AW300-24-0085, Rev. 1

SUBJECT: DC Generator Shaft Spline Wear/Corrosion

EFFECTIVITY: Challenger 300 (20006 - 20999)

Subject : Drive shaft mounting check on DC generator P/N A3579-101.

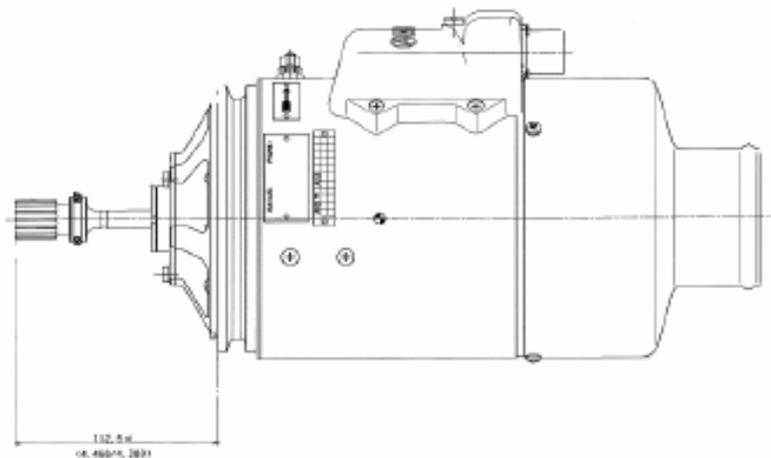
Here below is the outside dimension to be checked if the drive shaft is correctly connected inside the hollow shaft.

Dimension is 112,5 mm (+/- 1mm).
